FRONT AXLE SWAY BAR CLAMPS BECOMING LOOSE VOLVO 9700 (B13R)

MODEL YEAR(S) AND VEHICLE SERIAL NUMBERS (VIN) INVOLVED

VBC Bulletin	S-6985
Fail Code	16.06
Defect Code	09
Syst.Cond.	B
Causal Part	984826

FIGURE 1: FRONT AXLE SWAY BAR ARRANGEMENT

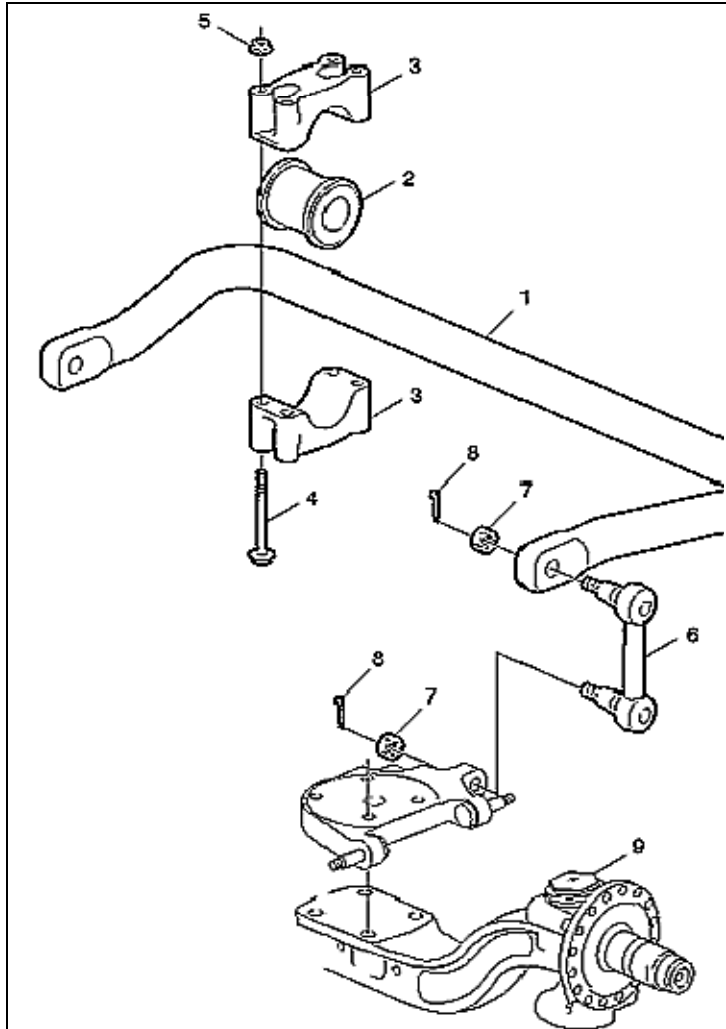
- 1) Lift the vehicle using mobile column wheel lifts so that the suspension is at the normal ride height.
- 2) Make sure that sway bar clamps are tight. There must be no gap between the lower and upper clamp halves when the bolts are tightened to proper torque.
- 3) Check that clamp bolts (4 bolts each side) are tightened to prescribed torque. If fasteners have become loose, new fasteners should be used.

- 4) If gaps are detected after the correct torque is applied on vehicles with 8.8 class bolts, the bolts must be replaced with 10.9 class bolts and tightened to the higher torque level. In some cases,

depending on the installation, the old bolts must be cut and the new ones installed in reverse position. There is no need to replace the clamps or the rubber bushing.

#3: CLAMPS

#4: FLANGE SCREW 984826

#5: NUT 990952

FIGURE 2: FRONT SWAY BAR CLAMP BOLTS

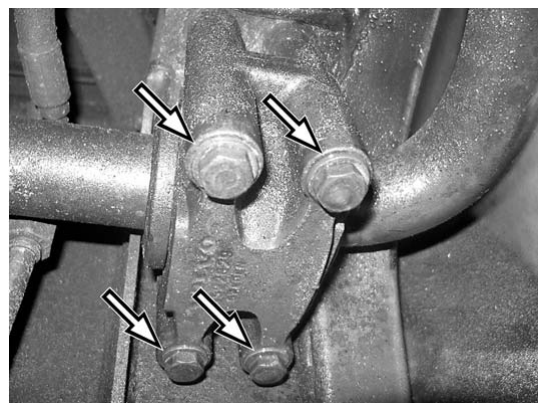
For proper torque value, clean the bolt head to identify which bolt class is present on the vehicle.

- **8.8 class bolts** = 63 ± 11 lbf-ft (85 ± 15 Nm)
- **10.9 class bolts** = 77 ± 15 lbf-ft (105 ± 20 Nm)

Never use oil, Vaseline or similar product. Make sure that the clamp and the rubber bushing are properly aligned and then tighten bolts to the proper torque if applicable. The clamps must not be pressed on using a jack or similar equipment.
